TECHNICAL BULLETIN

LT303-004

Discovery II - Method Change - Viscous Fan Renew

Situation: Change to Methods for removal and installation of the viscous fan assembly.

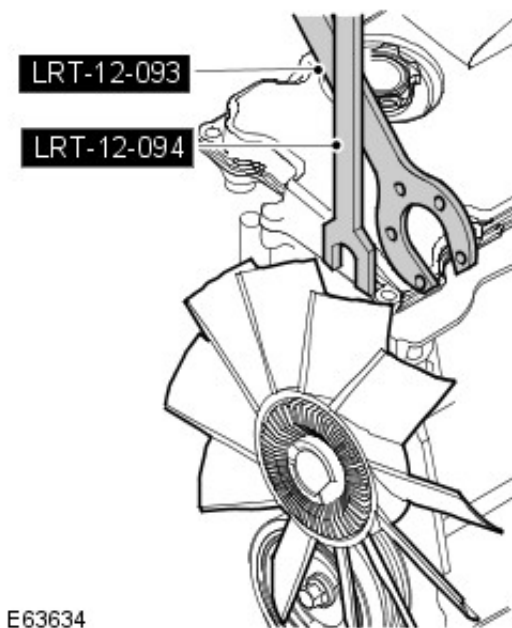
- Step for removal of acoustic cover - deleted.

- 1 Remove the upper fan cowl.
- 2 Remove the viscous fan coupling unit, using tools LRT-12-093 and LRT-12-094.

- 3 Position the viscous fan coupling unit and tighten using tools LRT-12-093 and LRT-12-094.
- 4 Install the upper fan cowl.
